Consultant	Wahib Medanat Consultant Engineer	Rep No.	11-07092021
Contractor	Derar Saraireh & Sons for Engineering & Contracting	Tender No.	(11/2019/USAID/SKEP/3/S) Schools for a Knowledge Economy Project (SKEP) - Phase (3) Package (1, 2)
Site Name	Um Al Dananir Basic Mixed School- Al Balqa	Day/ Date	Tue. 07/09/2021
Duration of Project	450 Calendar Days	Total Project Budget	9,789,417.840 JD

Visit Notes

(Figure: 24)

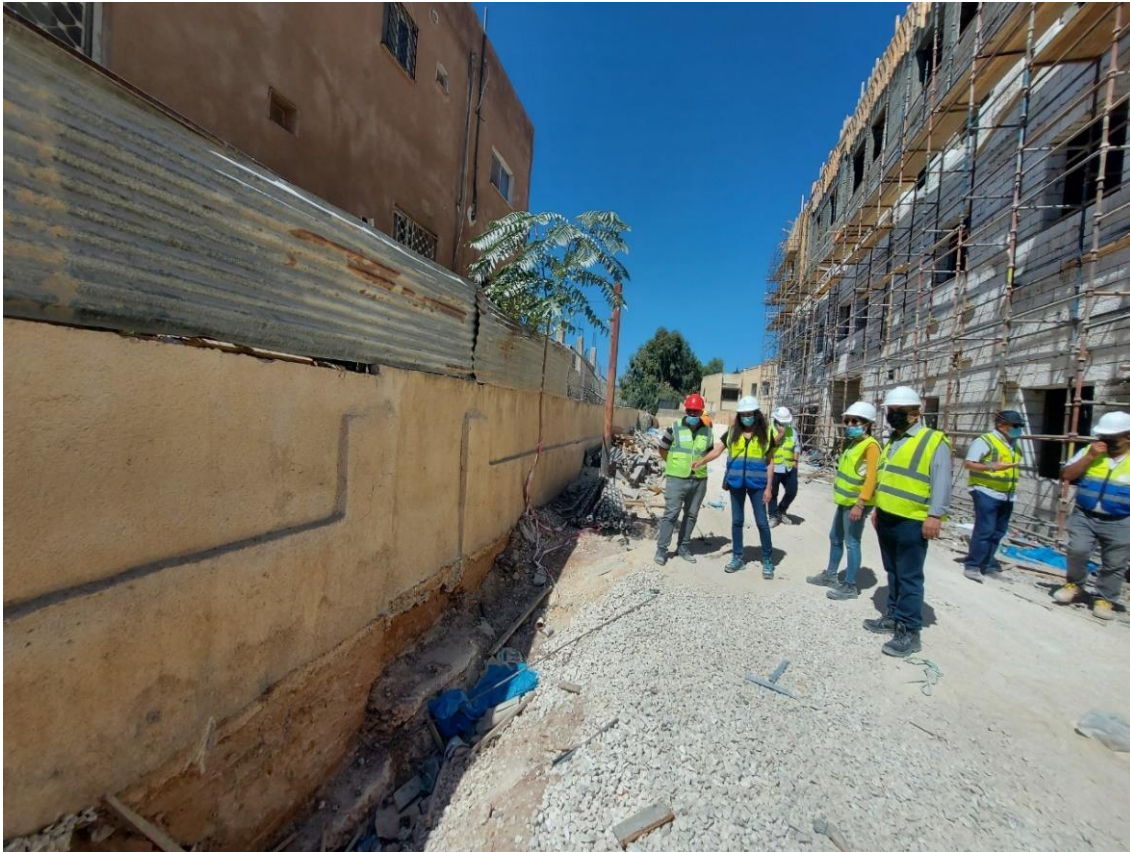
Doors' lintels casting
